Upper Valley Ranch Unit Two

City Plan Commission — July 30, 2026

CASE NUMBER/TYPE:	SUSU26-00031 – Resubdivision Combination
CASE MANAGER:	Alonso Hernandez, (915) 212-1585, HernandezJA5@elpasotexas.gov
PROPERTY OWNER:	FIRE Development, LLC.
REPRESENTATIVE:	Conde, Inc.
LOCATION:	North of Borderland Rd. and West of westside Dr. (ETJ)
PROPERTY AREA:	25.69 acres
VESTED RIGHTS STATUS:	Not Vested
PARK FEES:	\$100,010.00
EXCEPTIONS/MODIFICATIONS:	Yes, see following section
ZONING DISTRICT(S):	N/A Property lies within ETJ
PUBLIC INPUT:	No opposition received as of 07/22/2026

SUMMARY OF RECOMMENDATION: Staff recommends **PENDING** of Upper Valley Ranch Unit Two on a Resubdivision Combination basis and **PENDING** of the exception requests.

Figure A: Proposed plat with surrounding area

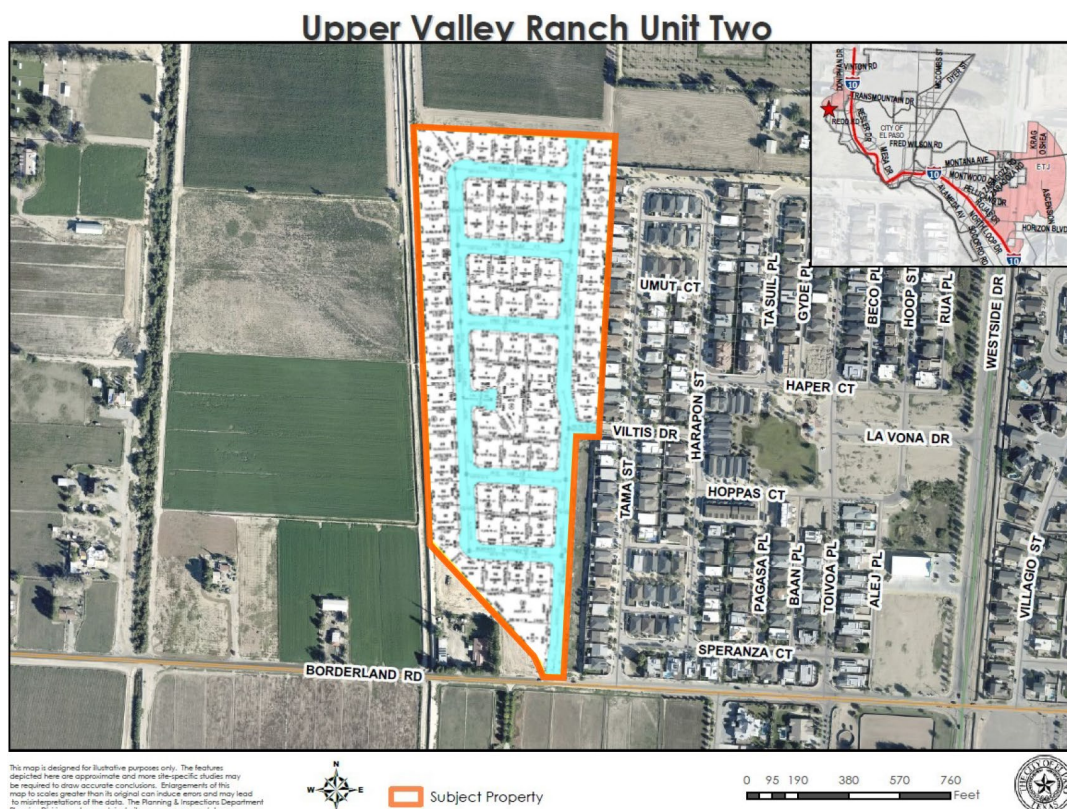
- To exceed maximum block length and block perimeter for block 2
- To waive the dedication of 5 feet of additional right-of-way on both sides along Viltis Drive.
- To waive the dedication of 3 feet of additional right-of-way on both sides for all proposed streets within the subdivision.

- To allow Block 2 to exceed the maximum block perimeter of 2,400 feet and the maximum block length of 1,000 feet.

- To waive the dedication of 5 feet of additional right-of-way on both sides along Viltis Drive.
- To waive the dedication of 3 feet of additional right-of-way on both sides for all proposed streets within the subdivision.

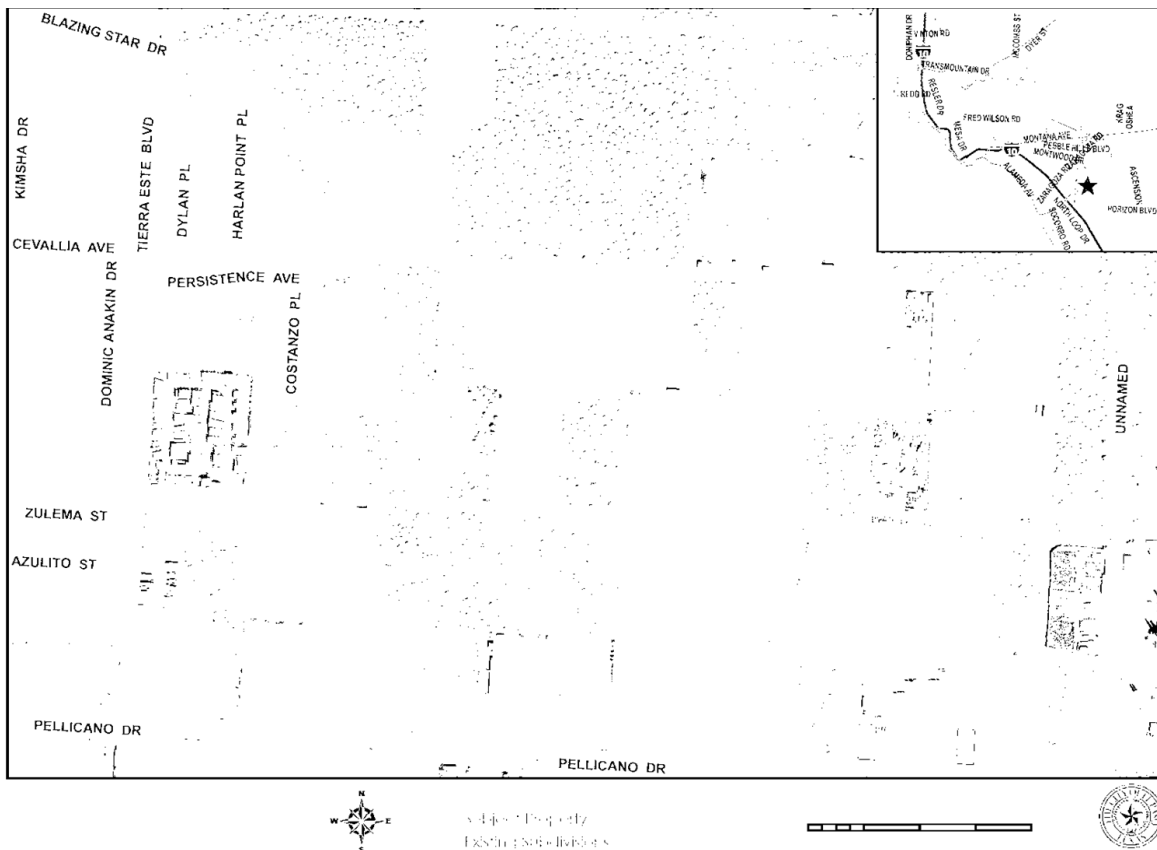
The City Plan Commission may waive such requirements to provide rights-of-way or street improvements to adjacent substandard roads based on any of the following factors:

a: Fifty per cent of the lots within a quarter mile of the proposed development have already been developed and the existing street improvements are in character with the neighborhood.
